The Commission has issued the enclosed Amendment No. 81 to Facility Operating License No. DPR-67 for the St. Lucie Plant, Unit No. 1. This amendment consists of changes to the Technical Specifications in response to your application dated March 17, 1987.

This amendment changes the Reactor Coolant System Pressure/Temperature (P/T) limit figures to be effective up to ten (10) effective full power years of operation. The amendment also changes the technical specifications dealing with overpressure protection systems because they are linked with the new P/T limit figures. The applicable bases sections are changed to reflect the above changes.

ST. LUCIE PLANT UNIT NO. 1

Amendment No. 81
License No. DPR-67

FIGURE 3.1-1b
MAXIMUM ALLOWABLE HEATUP AND COOLDOWN RATES, SINGLE
HPSI PUMP IN OPERATION

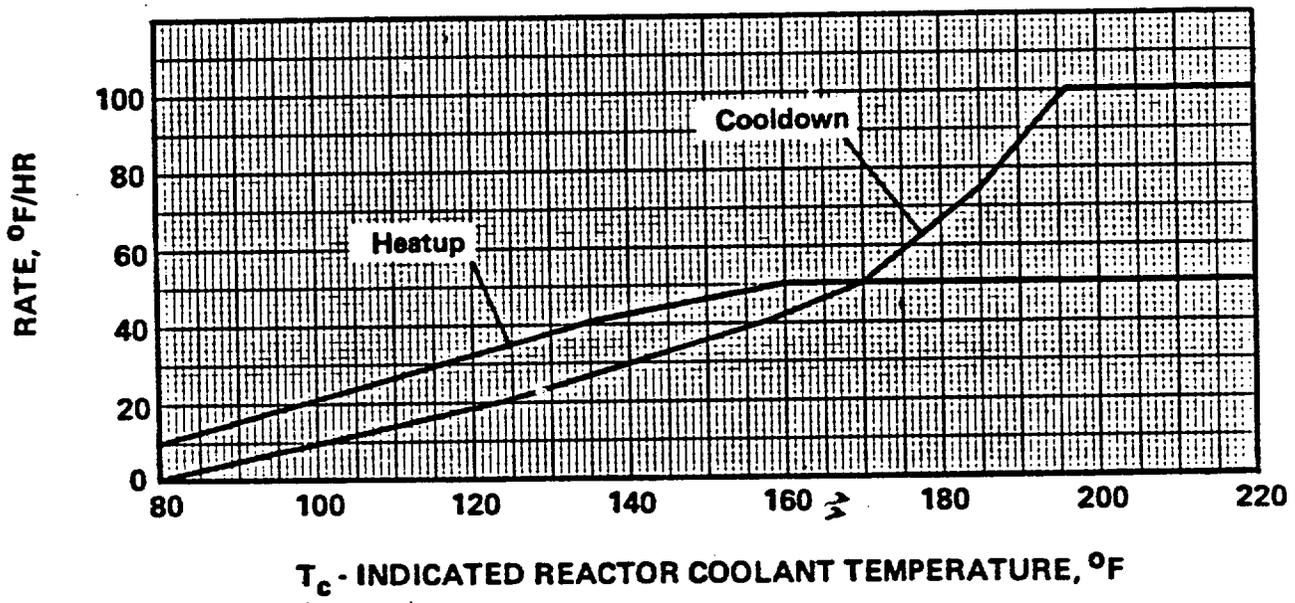
*The flow path from the RWT to the RCS via a single HPSI pump shall only be established if: (a) the RCS pressure boundary does not exist, or (b) no charging pumps are operable. In this case, all charging pumps shall be disabled, and heatup and cooldown rates shall be limited in accordance with Fig. 3.1-1b.

*The flow path from the RWT to the RCS via a single HPSI pump shall be established only if: (a) the RCS pressure boundary does not exist, or (b) no charging pumps are operable. In this case, all charging pumps shall be disabled and heatup and cooldown rates shall be limited in accordance with Fig. 3.1-1b.

*When the flow path from the RWT to the RCS via a single HPSI pump is established per 3.1.2.3, the heatup and cooldown rates shall be established in accordance with Fig. 3.1-1b.

FIGURE 3.4-2a
ST. LUCIE UNIT 1 P/T LIMITS, 10 EPFY
HEATUP AND CORE CRITICAL

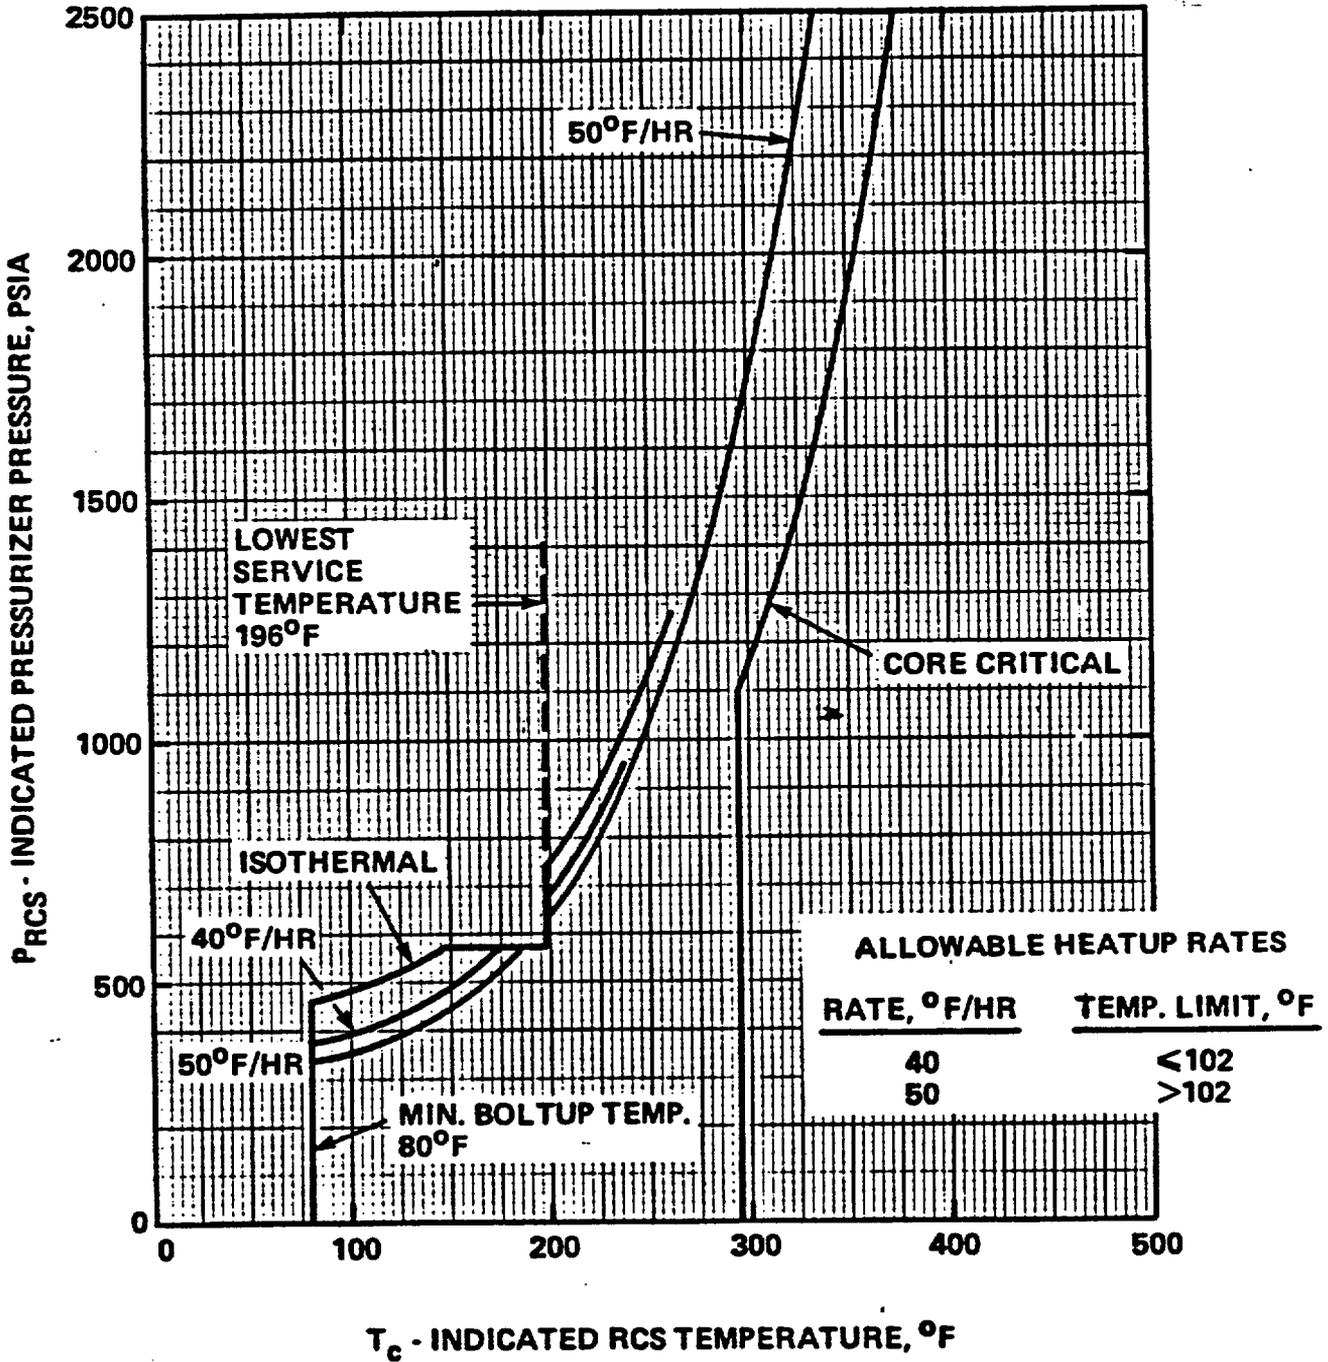
The St. Lucie, Unit 1 design uses power operated relief valves (PORVs) for overpressure protection during low temperature operating conditions. Pressure/temperature (P/T) limits for plant cooldown and heatup are specified in Figures 3.4-2a, 3.4-2b and 3.4-2c of the Technical Specifications (TS). The licensee's analyses documented in Appendix 5B of FSAR include (1) a postulated inadvertent reactor coolant pump (RCP) start event, assuming a maximum secondary to primary temperature differential of 100°F, and (2) a postulated inadvertent safety injection actuation event, assuming two high pressure safety injection (HPSI) pumps and three charging pumps injecting water into the reactor coolant system (RCS) for temperatures above 195°F, one HPSI pump and three charging pumps injecting water into the RCS for temperatures below 195°F with one HPSI pump disabled and three charging pumps injecting water into the RCS for temperatures below 155°F with both HPSI pumps disabled. All the above analyses performed to support LTOP system assume only one PORV operating during the overpressure transients.

Based on the results of a pressure transient analysis for the above events and the P/T limits presented in the revised Figures 3.4-2a, 3.4-2b and 3.4-3, the licensee, in its letter dated March 17, 1987, proposed system modifications and administrative controls as follows:

The licensee's above listed proposed modifications have been reflected in its proposed TS changes given in the introduction section of this report. The staff has reviewed the results of the licensee's reanalysis of pressure transients and its proposed TS changes and concludes that the proposed changes are adequate to prevent violation of the Appendix G P/T limits during an operating period ending at 10 EFPY.
